Technical Bulletin

Bulletin Number: 496 Revision Number: _____

SUBJECT: COIN INSERT DECAL COVER FOR COKE VRV

MODELS AFFECTED: All Coke VRV models.

Figure 1

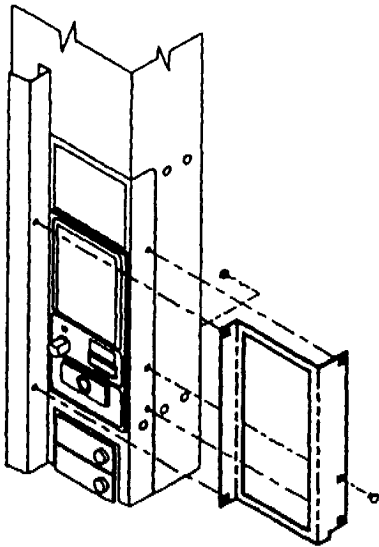
REASON: To provide a barrier to prevent vandals from peeling the coin insert decal.

1. Unplug the vender.
2. Remove the existing carriage bolt on the side of the door as shown in figure 1, page 1.
3. Use the carriage bolt to align the frame on the door as shown in figure 2, page 1.
4. Using the decal frame as a template, mark the holes to be drilled.
5. Remove the decal frame from the coin insert.
6. Drill five 5/16" diameter holes.

7. Place the decal frame in position. See figures 1 and 2 on page 1.
8. Secure the decal frame with carriage bolts and nuts.
9. Plug in the vender and test for proper operation.
